Further objections to application NY/2025/0030/ENV

Dr Susan Baxter  
25 Scholes Park Road  
Scarborough  
YO126RE

Issues with the Environmental Statement

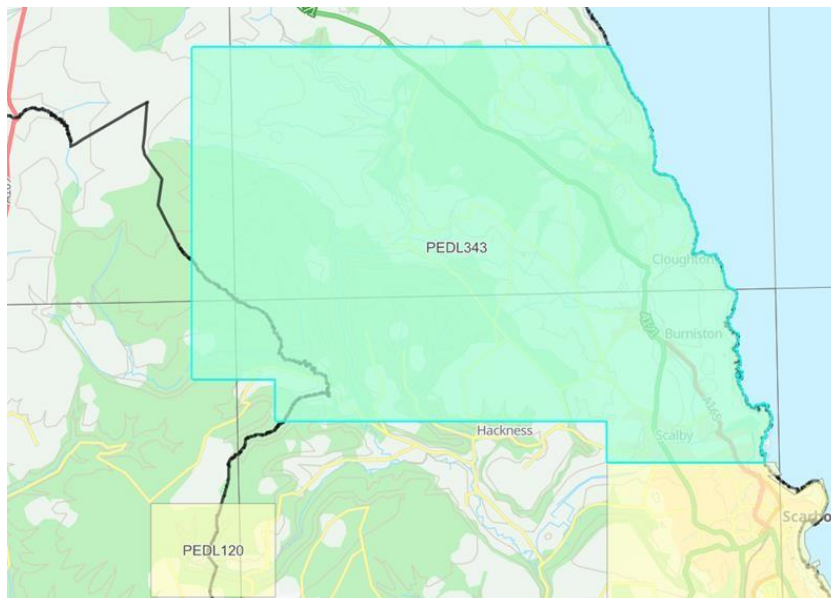
Section 5.4 of volume 1 of the Environmental Statement contains Europa’s perceived justification for the choice of location of the proposed site. The justification given is totally inadequate and fails to demonstrate that they assessed alternative sites properly. The licence area for exploration that they have been awarded (PEDL343) is large (covering 110 square kilometres) and there are many areas that could have been chosen that would not impact the heritage coast. Local tourism or be so close to local residents – see extract from the licence map shown below:

### Current view

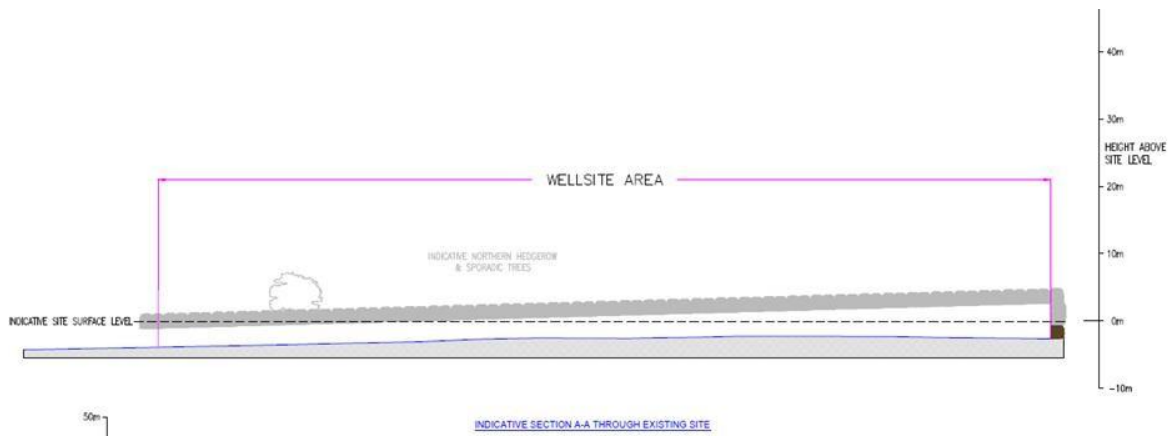
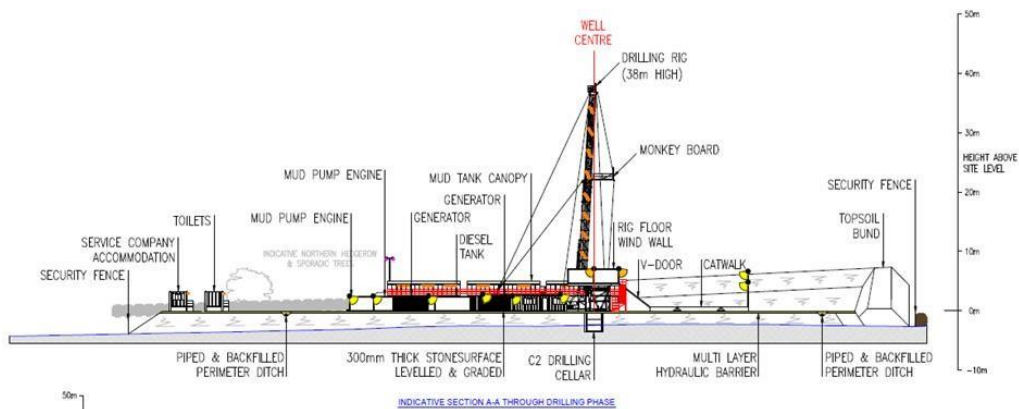
They claim that the development will “not be out of context in relation to the scale of the existing development”. This is clearly wrong as is evidenced by their own documents – see the extracts from the indicative drawings (two different views) submitted by Europa and available on the planning portal:

According to the justification supplied by Europa for choosing this site the development will be “well screened from the wider landscape” – as shown by their very own drawings this is evidently not true. They are damned by their own evidence.
